# Access Compliance Report

## Public Rights-of-Way

Intersection ID: 16290	Main Street: ELDER_AV	Cross Street: RICHLAND_DR	Location:	S
ADA ID: 2D5772B9800B	Ramp Type: Combination1	Initial Pass/Fail: Fail	Overall Compliance: No	Severity Score: 30

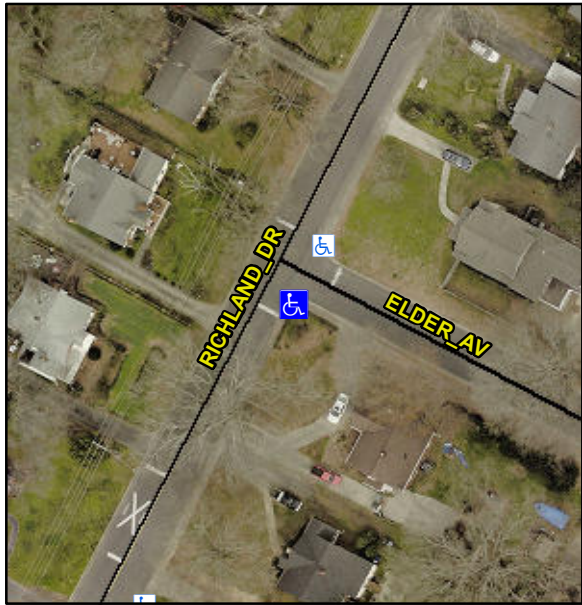
Codes/Mitigation Info/Possible Solution			Field Measurements/Component Compliance					
	Possible Solutions:		<b>Compliance</b>	<b>Description</b>	<b>Data</b>	<b>Compliance</b>	<b>Description</b>	<b>Data</b>
	<b>Remove &amp; Replace Entire Ramp.</b>		N/A	Ramp Length LT (in)	45.0	N/A	Ramp Length RT (in)	33.0
			Yes	Ramp Width LT (in)	48.0	Yes	Ramp Width RT (in)	48.0
			Yes	Ramp Slope LT (%)	0.4	Yes	Ramp Slope RT (%)	7.7
			Yes	Ramp XSlope LT (%)	0.9	Yes	Ramp XSlope RT (%)	1.7
			N/A	Ramp Length (in)	52.0	Yes	Ramp Slope (%)	2.8
			No	Ramp Width (in)	34.0	No	Ramp XSlope (%)	6.3
	Surveyor Notes:		N/A	Flare Type LT	N/A	N/A	Flare Type RT	N/A
	<b>LT RP &lt; 5%</b>		N/A	Flare Slope LT (%)	N/A	N/A	Flare Slope RT (%)	N/A
			N/A	Flare Traversable LT?	N/A	N/A	Flare Traversable RT?	N/A
PROW/ADA:		N/A	Landing Length (in)	N/A	N/A	DWS Provided?	N/A	
<b>Not Found, R304.5.1, R304.5.3</b>		N/A	Landing Width (in)	N/A	N/A	DWS Contrast?	N/A

N/A	Landing Slope (%)	N/A	N/A	DWS Length (in)	N/A	
		N/A	Landing X Slope (%)	N/A	N/A	DWS Full Width?	N/A	
		N/A	Landing Curb? (Y/N)	N/A	N/A	DWS Offset (in)	N/A	
		N/A	Shared Landing?	N/A				
		N/A	Gutter Ponding?	N/A	N/A	Gutter Slope (%)	N/A	
		N/A	Gutter Lip Ht (in)	N/A	N/A	Gutter X Slope (%)	N/A	
		N/A	Painted X Walk1?	No	N/A	Painted X Walk2?	N/A	
			X Walk 1 Direction	To NE		X Walk 2 Direction	N/A	
			X Walk 1 Width (in)	N/A		X Walk 2 Width (in)	N/A	
			X Walk 1 Slope (%)	1.7		X Walk 2 Slope (%)	N/A	
			X Walk 1 X Slope (%)	2.0		X Walk 2 X Slope (%)	N/A	
		N/A	Ramp inside XWalk1?	N/A	N/A	Ramp inside XWalk2?	N/A	
			Road Slope (%)	N/A		Clear Space?	N/A	
			Road X Slope (%)	N/A	N/A	Clear Space to XWalk (in)	N/A	
					N/A	Any Obstruction?	N/A	
						Obstruction Type	N/A	
								N/A
					N/A	Storm Grate/Utility Hazard?	N/A	
						Storm Grate/Utility Type	N/A	
								N/A
			Yes	Surface Condition? (G/P)	Good
